SELWYN DISTRICT COUNCIL

Review of Boffa Miskell Assessment of Glint and Glare at Buckleys Road Solar Farm

Date: 21 September 2023

Velden Aviation Consulting Ltd

Figure 5.3.1 *Branch Drain Road Solar Glare Plots*

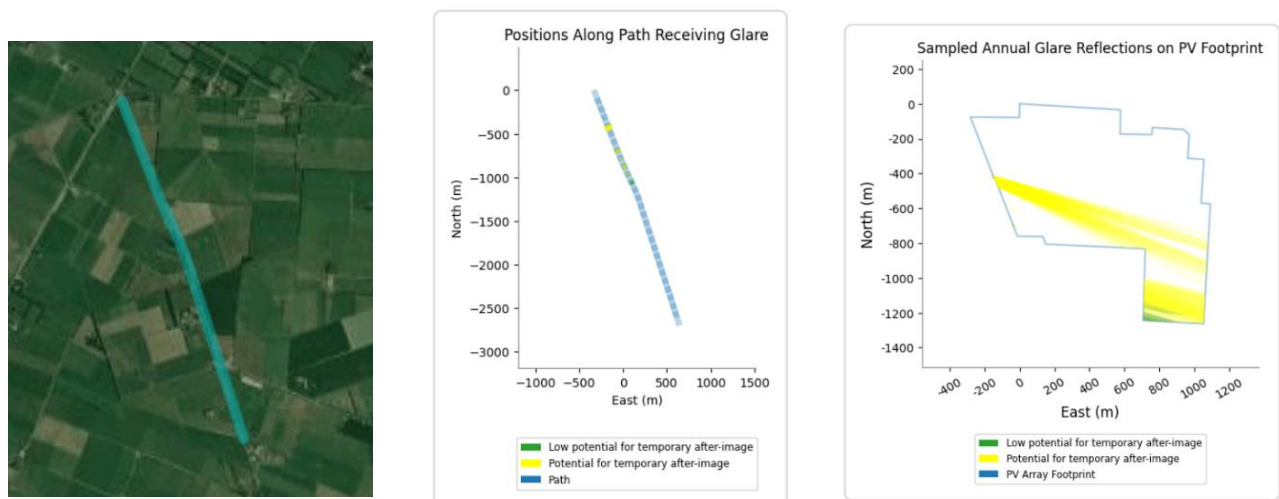
Figure 5.3.1 provides an example of footprint and associated road route for Branch Drain road. The ForgeSolar Solar Glare hazard analysis software does not initially take into account any existing or planned vegetation that provide screening unless it is specifically modelled.

Buckleys Road Annual Predicted Occurrence and Daily Duration of Glare.

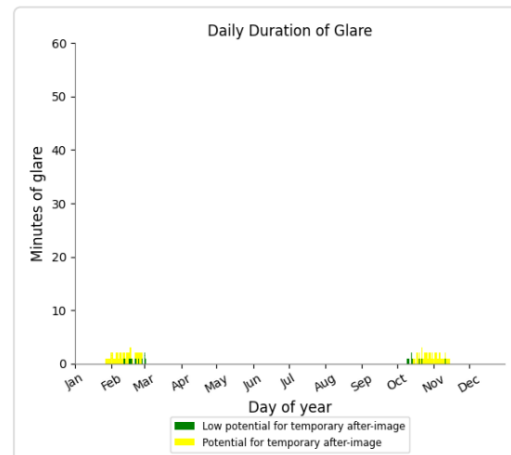
From Table 5.3 only two of the road routes, Irwell Rakai and Buckleys Roads, considered are expected to have yellow glare lasting an hour or more per annum.

Although the predicted yellow glare is minimal and likely to have less than minor impact, any further mitigation required to eliminate it completely should be easily addressed by considering plantings with growth to heights of more than 3.5m. These may only be required at very localised areas if needed at all.

Figure 3: Landscape Plan

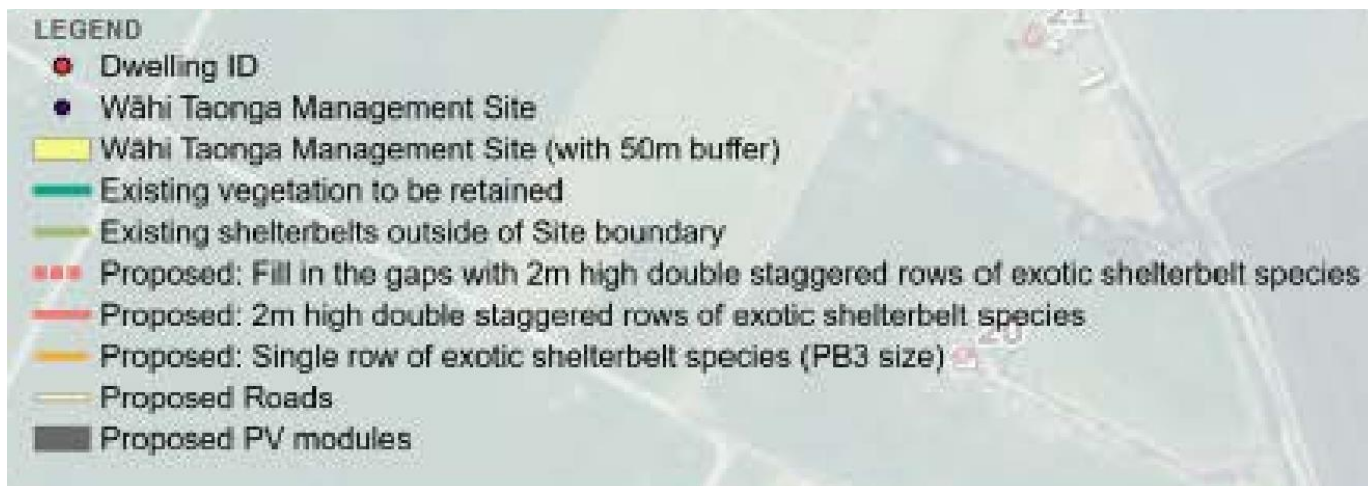
The landscape plan as proposed by Boffa Miskell in Figure 5.3.3 indicate existing vegetation as well as plans for additional planting. (**Appendix D** provides this in more detail along with the Legend)

Table 5.3 shows the results of predicted glare when the above vegetation and planned landscape plantings, upon reaching at least 3.5m in height, are taken into account and modelled on the solar glare software utility as obstruction to any potential glare. The glare is reduced to less than minor levels with potential yellow glare essentially eliminated.

Velden Aviation Consulting Ltd is satisfied with the Boffa Miskell further assessment and mitigation considerations based on their resultant amendment to eliminate backtracking for roads deemed to be susceptible to glare, for the period until road corridor plantings are established at a height of at least 3m.
